SAFETY RECALL

SR15-85

EXHAUST CLAMP REPLACEMENT AT TURBOCHARGER DIFFUSER PIPE 9700 (B13R)

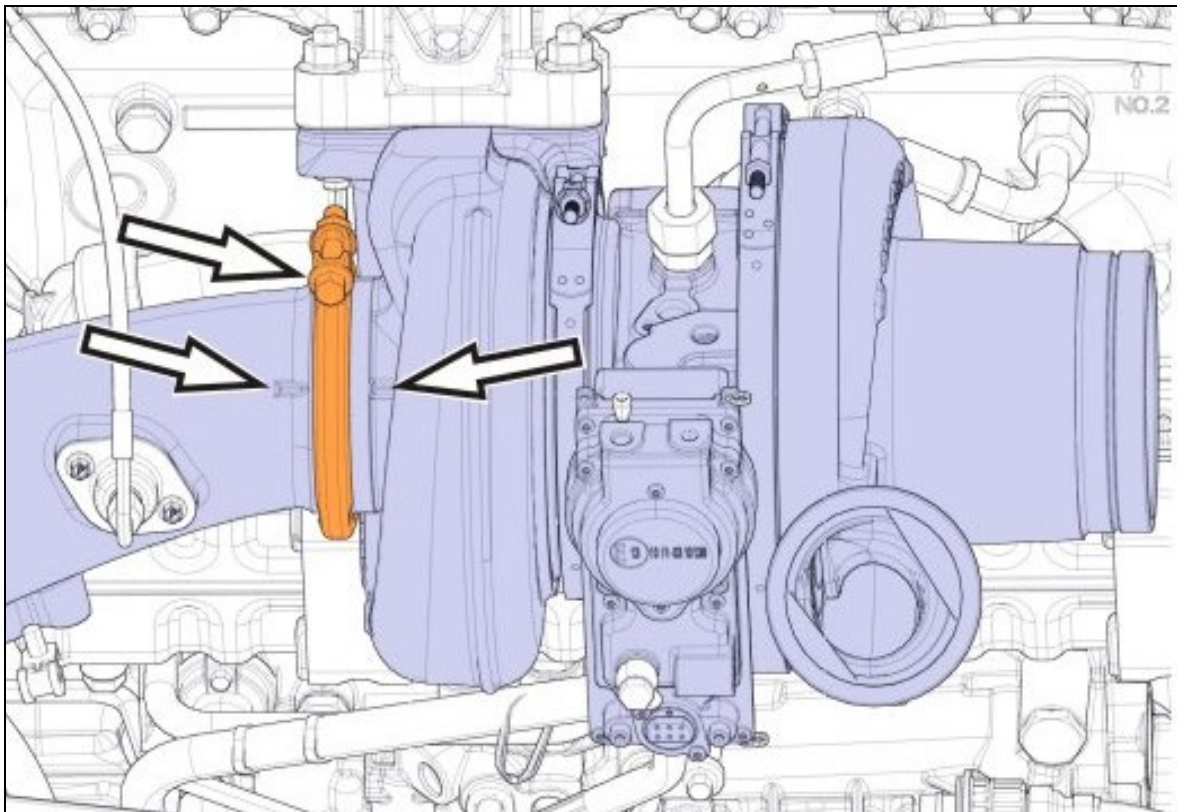
On the vehicles affected by this bulletin, the exhaust clamp that connects the turbocharger to the diffuser pipe may prematurely fail.

If this occurs, hot exhaust gases can leak and potentially ignite materials inside the engine compartment, which will increase the risk of an engine compartment fire.

Consequently, it is necessary to remove this clamp and replace it with a new reinforced clamp as soon as possible.

- Identity: 131589750 Engine Turbocharger, Replacement
 - Identity: 121793153 Radiator, Removal
 - Identity: 121786092 Radiator, Installation
- 1) Remove the radiator (refer to: Function group 26).
 - 2) Replace the turbocharger outlet pipe V-band clamp. Use a new gasket between the diffuser and turbocharger. Turn the diffuser pipe to the correct position (see figure below). Tighten the clamp to the proper specification. **V-band clamps..... 12 ± 2 Nm (106 ± 17 in-lbf).**

NOTE: WHEN POSITIONING THE DIFFUSER PIPE, ALIGN THE MATCH MARKS ON THE DIFFUSER AND ENGINE TURBOCHARGER, IF EQUIPPED.
